FE338

DESCRIPTIVE REPORT

Registry No. FE-338WD

Sublocality Southwest of Heald Bank

SHEET 40-2-72 H-9341 WD

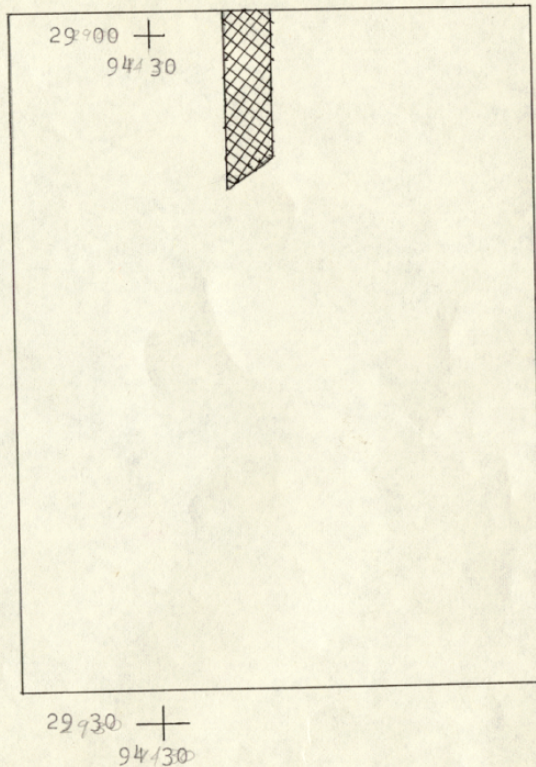
Operations began on DPR 479, Galveston, Sheet 40-2-73 on 11 June and terminated on 22 June. Work on boat sheet 40-3-72 began on 25 June and ended on 11 July, 1973; ^{wiredrag} work on sheet 40-2-72 began on 10 July, 1973, and terminated on 11 July, 1973. *but reconnaissance hydrography just east of those drag strips was done on 24 Oct. 1972 and other recon. hydro (not plotted by the field) was done on 27 & 28 June 1973 and 10 July 1973.*

SHEET 40-3-72 H-9342

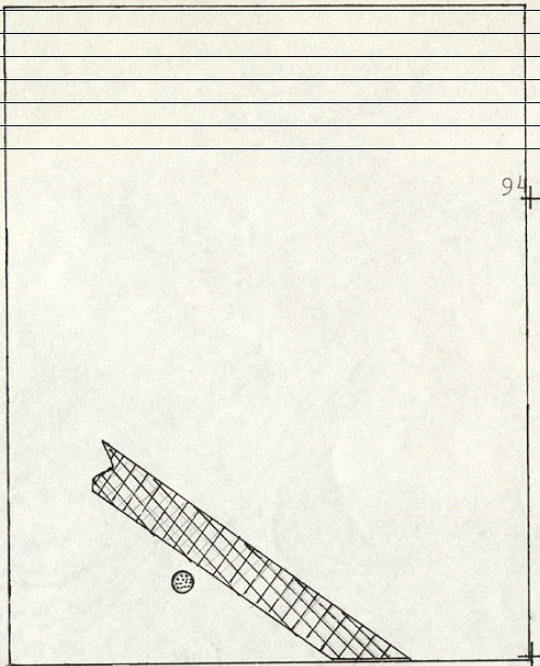
Towlines of 800 ft. and 1000 ft. were used the majority of the time thus putting the end buoys 265m and 326m respectively from the Raydist antennae. One exception exists; due to a weakened section of wire, the end vessel's towline during the drag on E-day (Sheet 40-3-72) was 235m long. For plotting purposes it was considered to be the standard 265m length. The shortened towline apparently increased the strain on the ground wire sufficiently to cause excessive lift in the end section (11-F). Because of the lift and because that section fell in an area of excessive overlap, it was rejected throughout the entire strip. The elimination of the section 11-F still left the strip with more than the specified 600 ft. overlap.
